**FEMA Levee Certification
Ventura County, California**

**Ventura River Levee (VR-1)
Pacific Ocean to Canada de San Joaquin**

**Evaluation Report
February 20, 2009**

- Exhibit 1 – Field Investigation Report
- Exhibit 2 – Preliminary Evaluation of Levee System Profiles
- Exhibit 3 – As-Built Plans Status List
- Exhibit 4 – Responses to Comments on Draft Evaluation Report

Ventura River Levee, From Ocean to Canada de San Joaquin. (Photo No. M25) – Freeway sign installed in levee bank, looking u/s (landward side)

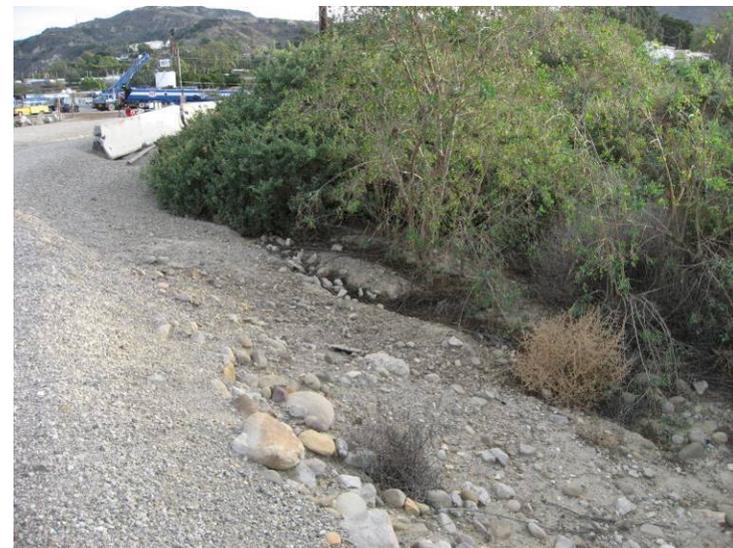
M23	Debris and K-rails along toe of levee (landward side)	Remove debris and K-rails (within the 15'-zone as appropriate)	C5 - PR issue (City of Ventura Fairgrounds)	E1	No permits needed, use BMPs	X		
M24	Freeway sign installed in levee embankment (landward side)	Relocation of signs may be required	C5, Cal-Trans	E1	No permits needed, use BMPs	X		
M25	Freeway sign installed in levee embankment (landward side)	Relocation of signs may be required	C5, Cal-Trans	E1	No permits needed, use BMPs	X		
M26	Power poles within 15' of levee toe	Relocation of utility poles may be required	C5 - Planning to coordinate removal of poles with SCE	E1	No permits needed, use BMPs		Are all static poles a problem?	Utility poles within the embankment prism (only 1 on SCR-1) must be relocated. These poles do not require relocation.
M27	Dumped debris over levee embankment (riverward side)	Remove debris (within the 15'-zone as appropriate)	C1	E2	Remove debris, repair slope as needed

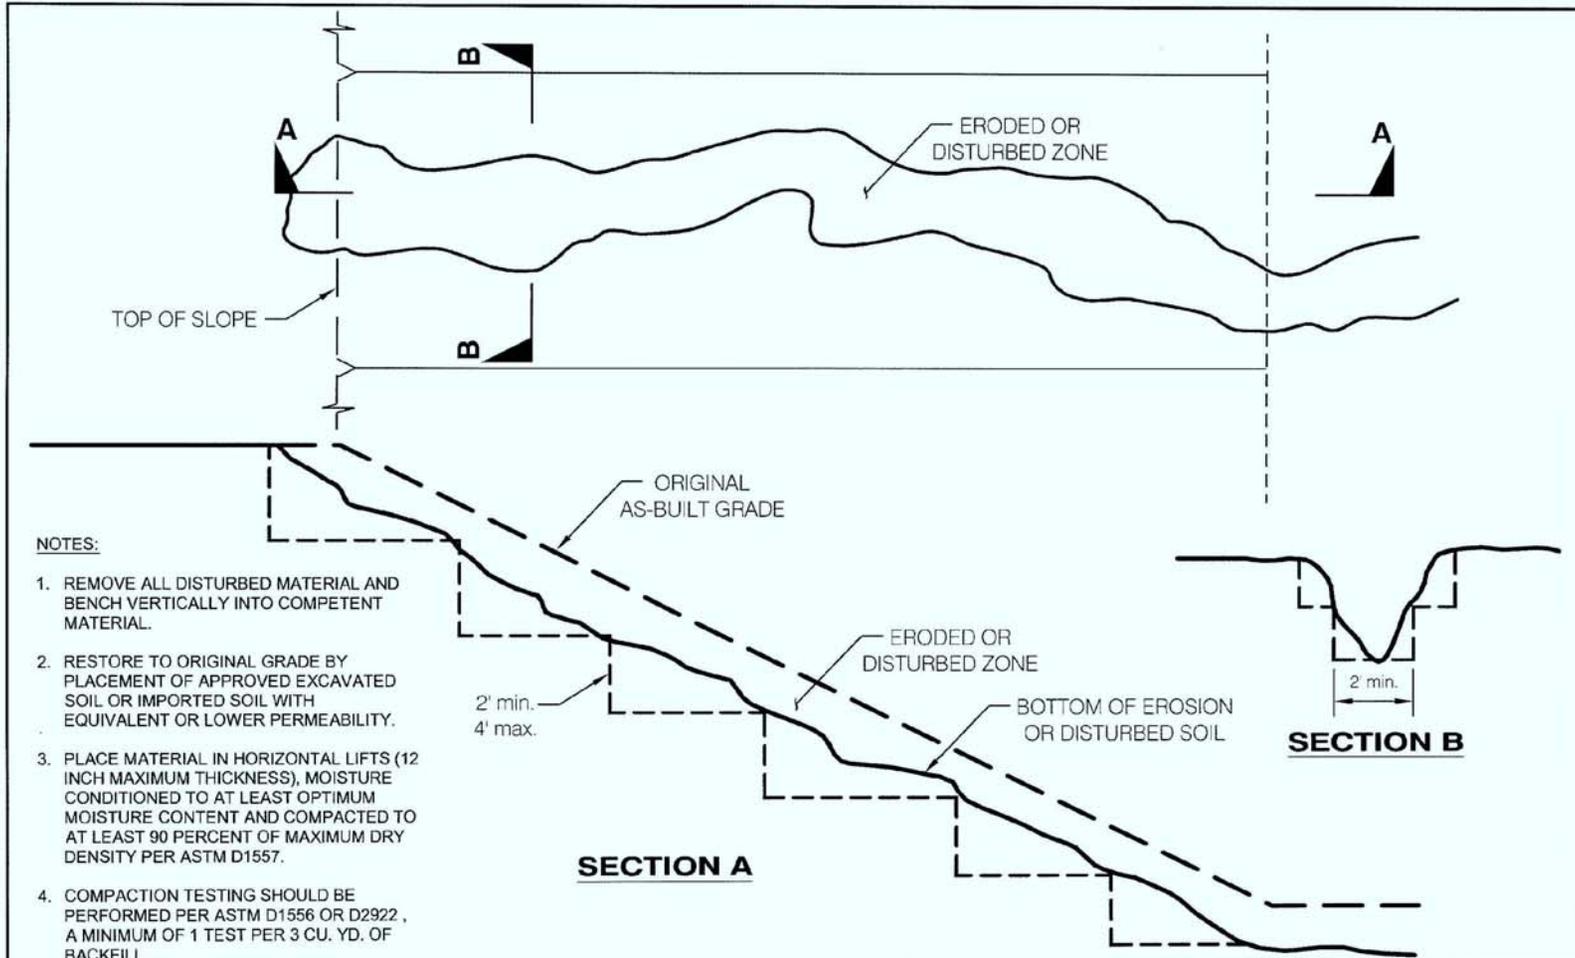
<p>4. Can Tetra Tech provide specs for compaction and grading requirements? Discuss major and minor repair examples.</p>	<p>Compaction requirements are detailed on the attached Figures 1 and 2. Major repair examples include any erosion feature that is deeper than 1 foot or that is greater than 2 feet wide. Major and minor animal burrows are discussed in item 1.</p>
<p>5. Can in-kind materials be used for backfill?</p>	<p>In-kind backfill would be materials free of organic or deleterious debris that has similar or lower permeability than the levee material. These materials could consist of excavated soil, imported soil, concrete, or slurry, and shall be evaluated by the testing and materials lab.</p>
<p>6. Discuss documentation/inspection requirements for verification of grading.</p>	<p>The requirements for verification of grading are discussed above.</p>

1. REMOVE ALL DISTURBED MATERIAL AND BENCH VERTICALLY INTO COMPETENT MATERIAL.
2. RESTORE TO ORIGINAL GRADE BY PLACEMENT OF APPROVED EXCAVATED SOIL OR IMPORTED SOIL WITH EQUIVALENT OR LOWER PERMEABILITY.
3. PLACE MATERIAL IN HORIZONTAL LIFTS (12 INCH MAXIMUM THICKNESS), MOISTURE CONDITIONED TO AT LEAST OPTIMUM MOISTURE CONTENT AND COMPACTED TO AT LEAST 90 PERCENT OF MAXIMUM DRY DENSITY PER ASTM D1557.
4. COMPACTION TESTING SHOULD BE PERFORMED PER ASTM D1556 OR D2922, A MINIMUM OF 1 TEST PER 3 CU. YD. OF BACKFILL.

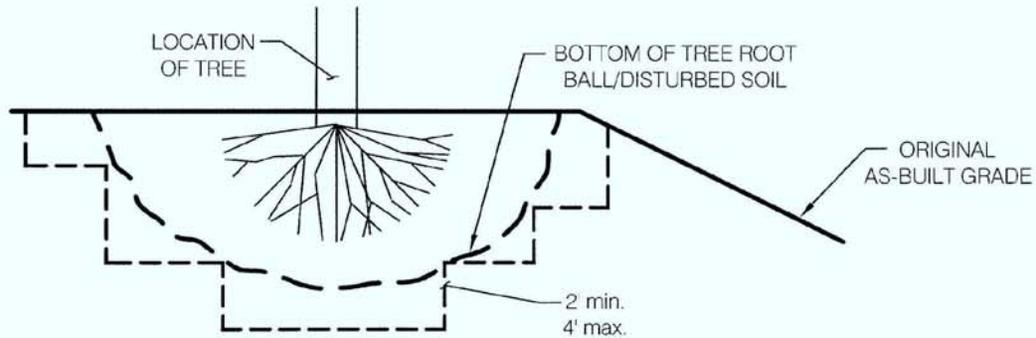
<p>2. Please describe methods for vegetation and rootball removal.</p>	<p>4" DIAMETER TRUNK OR GREATER: Cut the woody vegetation approximately two (2) feet above ground level leaving a prominent stump for use in the rootball extraction process. Remove the stump and rootball by pulling or extracting with a backhoe or similar equipment. Clean the rootball cavity of all loose soil and remaining root system (roots greater than 1/2" diameter). Prepare the cavity by excavating per FIGURE 2. Backfill with excavated soil or imported soil with equivalent or lower permeability. Place material in horizontal lifts no greater than twelve (12) inches. Moisture conditioned to at least optimum moisture content and compacted to at least ninety (90) percent of the maximum dry density of the fill soil per ASTM D1557. Compaction typically requires the use of manually operated compaction equipment or compaction attachment to a backhoe. Compaction testing should be performed per ASTM D1556 or D2922. A minimum of one (1) test per three (3) cubic yards of backfill.</p> <p>2"-4" DIAMETER TRUNK: Cut the woody vegetation stump flush with the ground. Treat the stump with a protective coating similar to polyurethane to prolong the decay process.</p>

1. REMOVE ALL DISTURBED MATERIAL AND BENCH VERTICALLY INTO COMPETENT MATERIAL.
2. RESTORE TO ORIGINAL GRADE BY PLACEMENT OF APPROVED EXCAVATED SOIL OR IMPORTED SOIL WITH EQUIVALENT OR LOWER PERMEABILITY.
3. PLACE MATERIAL IN HORIZONTAL LIFTS (12 INCH MAXIMUM THICKNESS), MOISTURE CONDITIONED TO AT LEAST OPTIMUM MOISTURE CONTENT AND COMPACTED TO AT LEAST 90 PERCENT OF MAXIMUM DRY DENSITY PER ASTM D1557.
4. COMPACTION TESTING SHOULD BE PERFORMED PER ASTM D1556 OR D2922, A MINIMUM OF 1 TEST PER 3 CU. YD. OF BACKFILL.
